Access Compliance Report

Public Rights-of-Way

(Curb Ramps)

Intersection ID: 30465	Main Street: PLANTERS_ROW_DR	Cross Street: GOLDEN_VIEW_DR	Location: NE
ADA ID: D8EF877786A4	Ramp Type: Directional1	Initial Pass/Fail: Fail	Overall Compliance: No
		Severity Score: 25

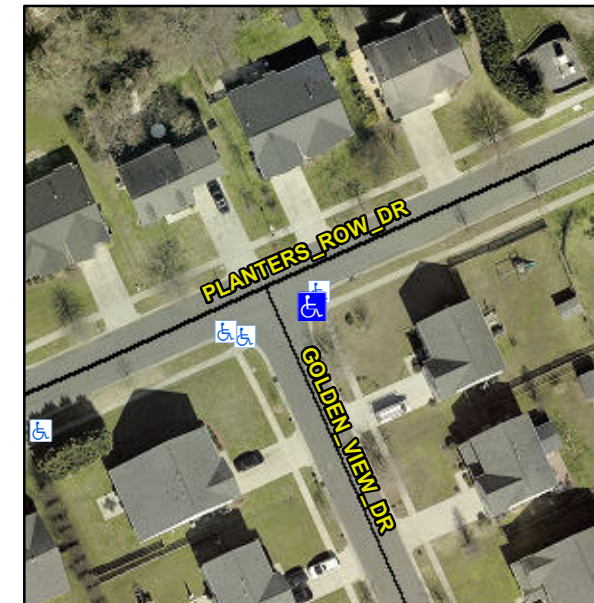
R304.5.3

Compliance	Description	Data	Compliance	Description	Data
N/A	Ramp Length (in)	48.0	N/A	Grade Break?	N/A
Yes	Ramp Width (in)	57.0	N/A	Grade Break Slope (%)	0.0
Yes	Ramp Slope (%)	4.7	N/A	Grade Break XSlope (%)	0.0
No	Ramp XSlope (%)	8.9			
N/A	Flare Type LT	N/A	N/A	Flare Type RT	N/A
N/A	Flare Slope LT (%)	N/A	N/A	Flare Slope RT (%)	0.0
N/A	Flare Traversable LT?	N/A	N/A	Flare Traversable RT?	N/A
N/A	Landing Length (in)	0.0	N/A	DWS Provided?	N/A
N/A	Landing Width (in)	0.0	N/A	DWS Contrast?	N/A
N/A	Landing Slope (%)	0.0	N/A	DWS Length (in)	N/A
N/A	Landing X Slope (%)	0.0	N/A	DWS Full Width?	N/A
N/A	Landing Curb? (Y/N)	N/A	N/A	DWS Offset LT (in)	N/A
N/A	Shared Landing?	N/A	N/A	DWS Offset RT (in)	N/A
N/A	Gutter Ponding?	0.0	N/A	Gutter Slope (%)	N/A
N/A	Gutter Lip Ht (in)	0.0	N/A	Gutter X Slope (%)	N/A
N/A	Painted X Walk1?	No		Road Slope (%)	3.2
	X Walk 1 Direction	To SW		Road X Slope (%)	2.4
	X Walk 1 Width (in)	N/A		Clear Space?	N/A

Remove & Replace Entire Ramp.
